RE: Stillbrooke Homes at La Mirada Subdivision on Wymont Circle – Erosion & Sediment Control Plan G19E004A_SB (SWQ-2026-00008)

STILLBROOKE HOMES AT LA MIRADA SUBDIVISION - LOTS 2-6, 15-24, 55-62

TEMPORARY SEDIMENT AND EROSION CONTROL DRAWINGS

CUTBACK CURB

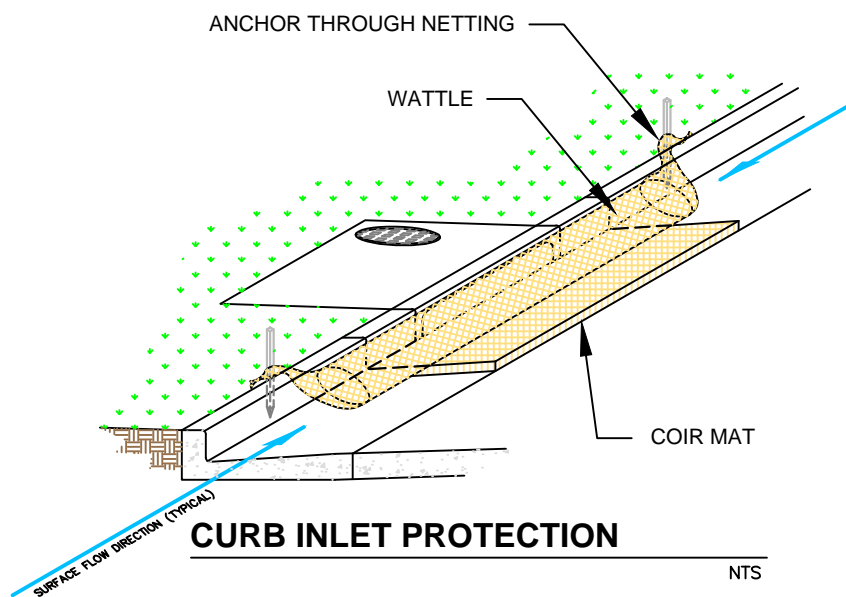
With respect to the detention pond, this requirement is relevant for mass grading, but not for vertical construction. The SWQ department defaults to its preference to calculate a sediment basin's size based on 3,600 c.f. per acre drained. However, it omits the 'or' in Part 2.2.12 which allows the operator to design a sediment basin, if installed, around the calculated volume of runoff from a 2-year, 24-hour storm. The existing detention pond is sized to accommodate a 10-year storm.

The Operator(s) are only responsible for the permitted disturbed areas (e.g., the lots they own). They are not responsible for the entire commercial and residential subdivisions. While impractical, we can develop small sediment basins for each lot, or acknowledge the cutback curb is a pond, and contains stormwater discharge as it moves toward the street. If needed, the operator can adjust the depth of the cutback curb to accommodate more volume.

THE LOWEST POINT OF THE SEDIMENT POND SHALL BE AT LEAST 10 INCHES.

THE DEPTH AND LENGTH OF THE EXCAVATED AREA CAN BE INCREASED IF MORE STORAGE IS NEEDED.

SHEET:

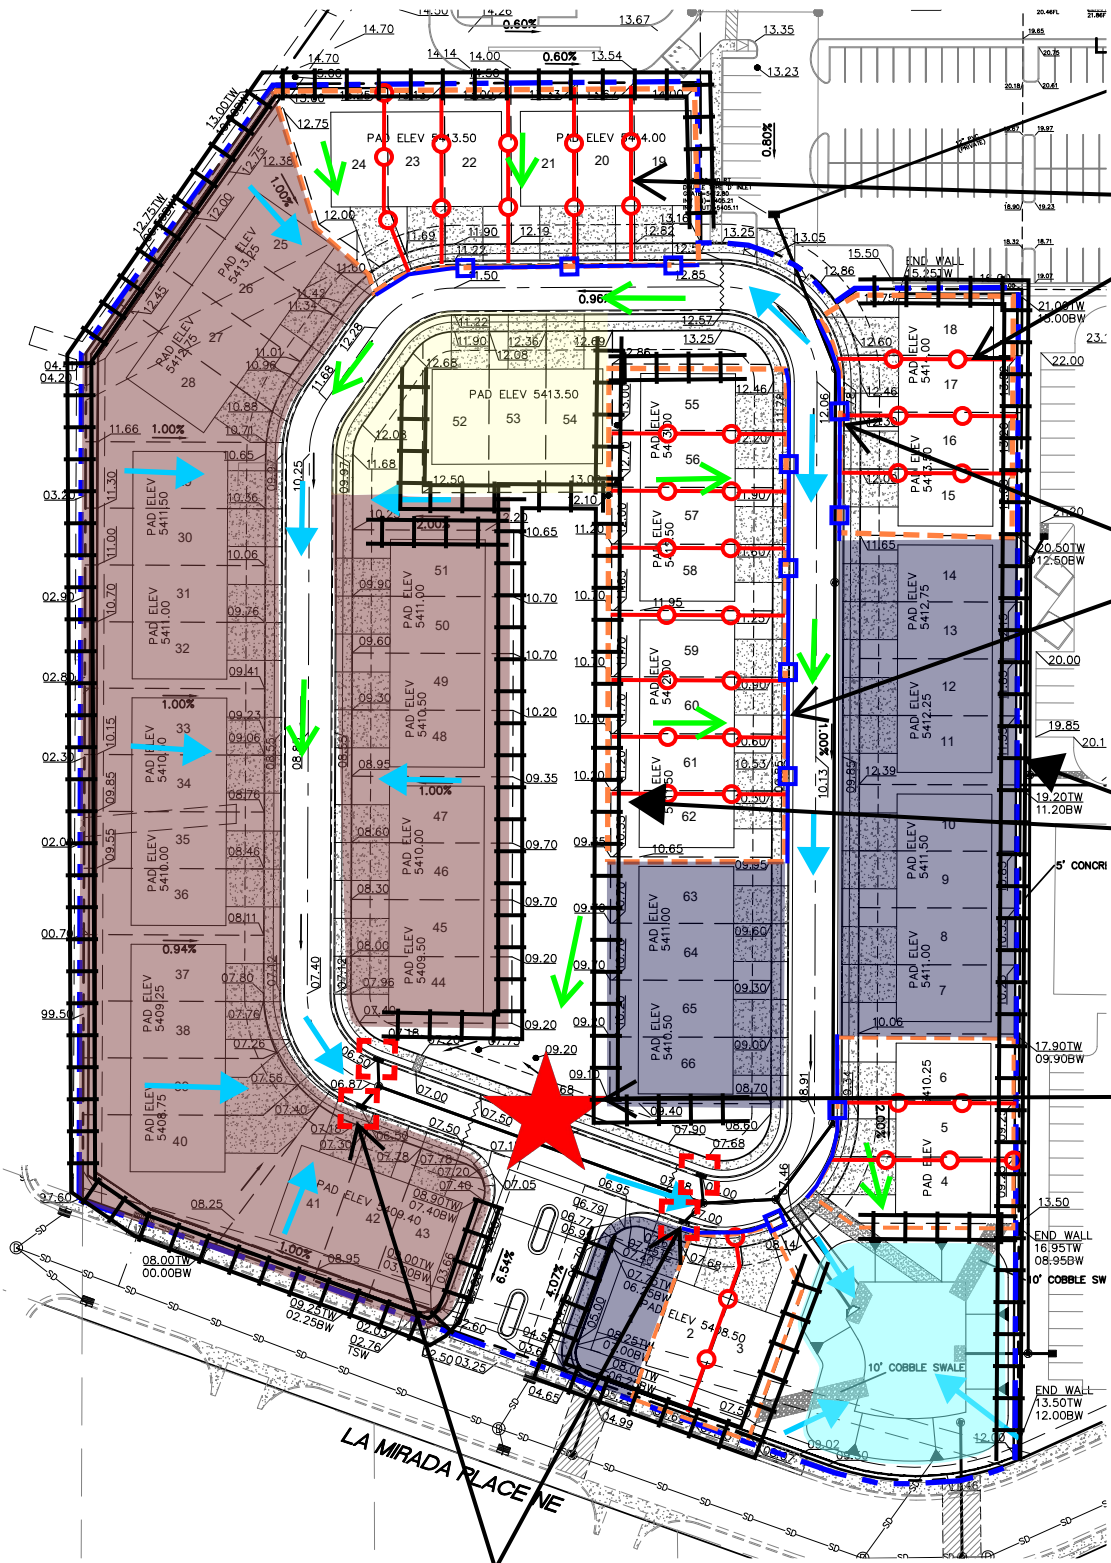
During review, we identified that Wymont, LLC (NPDES ID NMR10044X) also needed to be included on the plan in addition to the ones previously identified as an active operator for the relevant lots.

4. COA Comment 4 is difficult to parse and appears to be circular. It is not clear what the City's expectation is, or what BMP it will accept. We believe your comment is direction to install silt fence between each lot, and a cutback curb along the street. We have made this change to the TESCP.

We cannot claim to know the status of the work authorized under permits NMR10040Z or NMR10044X, or why they are still active if the work is complete. Similarly, the NOIs do not specify which lot/s the authorizations are for. However, to comply with CGP Part 7.2.1 and 9.6.1.c.i, we labeled the lots based on the Bernalillo County Assessor's data.

- NPDES ID: NMR1006BR, TWILIGHT HOMES, LLC
- NPDES ID: NONE, AMRESTON HOMES, LLC
- NPDES ID: NMR10044X, WYMONT, LLC

OPERATOR OVERSITE:
THE HIGHLIGHTED LOTS ARE MANAGED AND THE RESPONSIBILITY OF THEIR RESPECTIVE PROPERTY OWNER.

AS OF THE DESIGN DATE OF THIS TESCP, THE BERNALILLO COUNTY ASSESSOR INDICATES AMRESTON HOMES, LLC OWNS THE IDENTIFIED LOTS. THE NOI FOR AMRESTON HOMES, LLC ASSOCIATED WITH THESE LOTS WAS NOT LISTED ON THE EPA'S PUBLIC SEARCH SITE.

THE EPA PUBLIC PERMIT SEARCH PROVIDES AN NOT FOR AMREP SOUTHWEST, INC. FOR THE LA MIRADA SUBDIVISION (NMR10040Z), HOWEVER, AMREP SOUTHWEST, INC. IS NOT CURRENTLY IDENTIFIED AS A PROPERTY OWNER FOR AN RESIDENTIAL LOT.
